Development at Gowan Motors
Site, Naas Road

Cycle Audit

Document Ref: P23063-PMCE-XX-XX-RP-QA-GEN-1_00_01

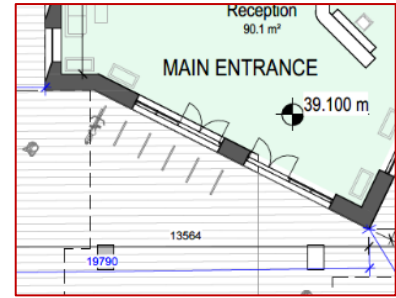
Whilst the long stay parking provision is below the required number of bicycle parking spaces, the proposed provision represents 99.7% of the Local Authority's requirement. As such, it is considered that the Long-stay cycle provision is broadly in line with requirements. Additional long-stay (secured and sheltered) bicycle parking spaces should be provided for the Commercial Retail and Cultural / community space.

Cycle Audit Reference	Summary of Issue	Design Team Response/Action
2.1	Bicycle Parking	Additional long-stay parking for commercial and community spaces now added to the drawings.

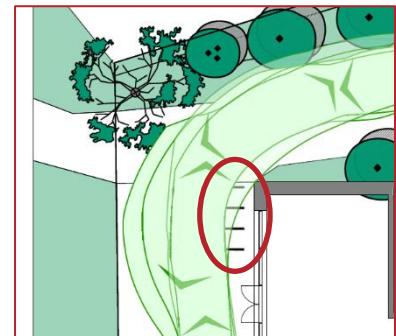
Swept paths of a refuse truck and fire tender travelling through the development's vehicular route have been provided. The swept path of a fire tender is indicated as passing through bicycle parking stands adjacent to Block 1 which would result in material damage to the bicycle parking stands, or bicycles parked there if occupied.

Short stay bicycle parking location should be located at accessible and safe locations without conflicting or blocking the carriageway or footway.

2.2	Bicycle Parking Locations	Bicycle spaces have been relocated to avoid the obstruction.
2.3	Bicycle Parking Locations	Bicycle spaces have been relocated to avoid the clash with the fire tender route.

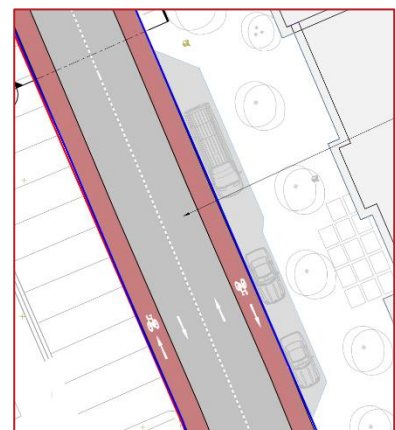
It is unclear from the information provided whether the bike store door is manually operated or electrically powered. Manually operated doors may present difficulties for cyclists accessing/egressing the long term Bicycle Parking.

Doors used by residents with their bicycle should be at least 1.2m wide, preferably operated electronically by automatic detection or with the push button within 3m of the door.

2.4	Bike Store Doors	Electronically operated doors, min 1.2m wide, will be provided.
2.5	Roadside Parking Area	A buffer zone of 0.75m has been added to avoid potential clash between cyclists and car doors.
